Tendring District Council (TDC) – Procedural Deadline 3 Response including:

- **TDCs comments on Applicants submissions received by Deadline 2**
- **TDCs responses to ExQ Questions (1)**

Application by National Grid for a Development Consent Order (DCO) for the proposed Norwich to Tilbury project.

Location of Wick Lane (protected Lane)

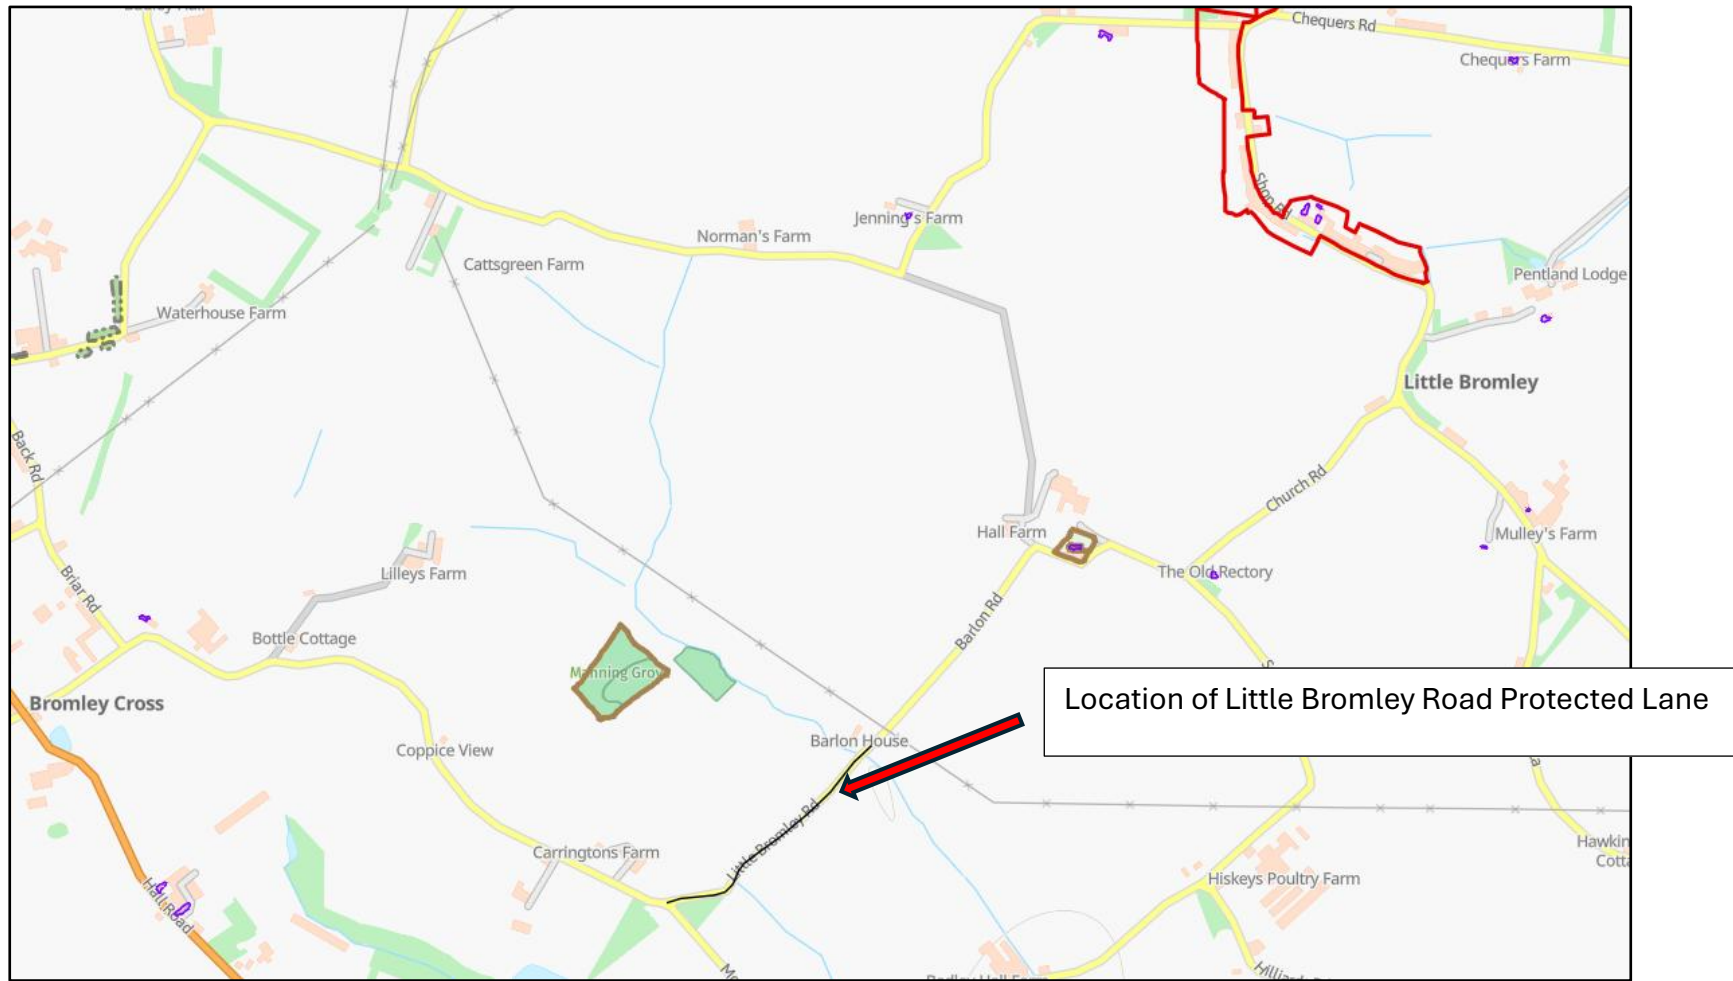
<p>In addition, the Council’s Emerging Local Plan (Regulation 18 consultation recently concluded) again confirms their heritage significance:</p> <ul style="list-style-type: none"> • Page 27 and Page 137 identify Protected Lanes as features preserved for their <i>historic indication of ancient road patterns</i> within the District. • Emerging Policy PPL3 states that the Council “<i>will protect the rural landscape and refuse planning permission for any proposed development which would cause material harm to its character or appearance, including to protected lanes, other rural lanes, bridleways and footpaths.</i>” <p>Furthermore, under the heading Non Designated Heritage Assets (page 147), the emerging Local Plan states:</p> <p><i>“The District benefits from a wealth of non-designated heritage assets that are locally significant and contribute positively to the area’s character and distinctiveness. This may be due to their historic, aesthetic, evidential, or communal value, or a combination of these factors. Examples include houses, shops, schools, village halls, churches, protected lanes...”</i></p> <p>This makes it unmistakably clear that Protected Lanes fall within the Council’s own defined examples of NDHAs due to their historic and evidential value.</p> <p>Finally, following the Regulation 18 consultation, the council is not aware of any objections being lodged against the continued designation of Tendring’s nine Protected Lanes – two of which would be negatively affected by the Norwich to Tilbury proposals as set out above. Their protection is therefore both well established and currently uncontested within the emerging policy framework.</p>
